AN ORDINANCE OF THE CITY OF REDMOND,
WASHINGTON, ADOPTING THE HEARING
EXAMINER'S OCTOBER 22, 2003
RECOMMENDATION TO APPROVE WITH
CONDITIONS THE FAIRWINDS RETIREMENT
COMMUNITY PLANNED RESIDENTIAL
DEVELOPMENT (L030003) AND CONDITIONAL USE
PERMIT (L030004) AND ESTABLISHING AN
EFFECTIVE DATE.

SUBJECT: Fairwinds Retirement Community #L030003, L030004

FILE NO: L030003, L030004

ATTACHMENT A SITE PLAN

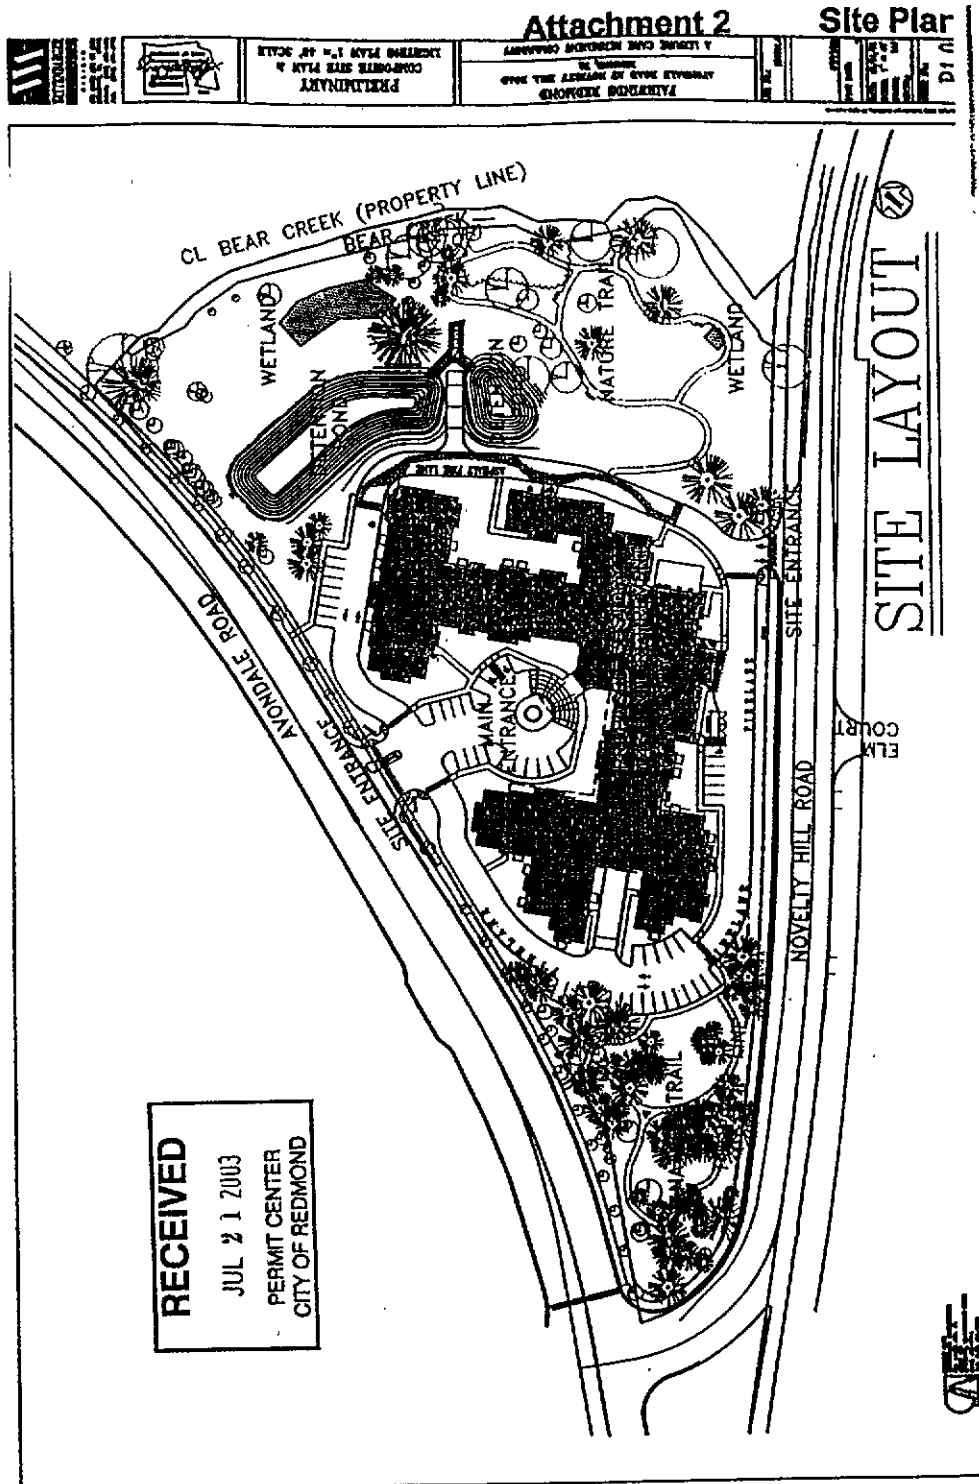
Revised building elevations that reflect Design Review Board comments at 1/8" scale prepared by a licensed architect must be submitted with the building permit application. Design Review Board requirements are as follows:

1. Instead of deciduous trees, plant more evergreen trees in the foundation landscape areas for the building wings that are closest to Avondale road, especially where the building height is at three stories.
2. Sidewalks should be differentiated from the vehicular paths by texturing, color, or use of a different material. This is especially necessary for the sidewalks running along the garage driveways, and where pedestrian paths cross vehicular paths.
3. The lighting plan will be subject to the approval of the Technical Committee. The lighting fixture cut-off sheets shall be provided by the applicant to the City of Redmond for review.
4. Presentation of material inconsistencies

1 Along Avondale Road, evergreen trees are preferred to minimize the impact of
2 the three-story buildings from neighboring views. In addition, trees to be planted
3 in the foundation landscape areas of the building that is visible from Avondale
4 Road should use more evergreen trees than deciduous trees.
5
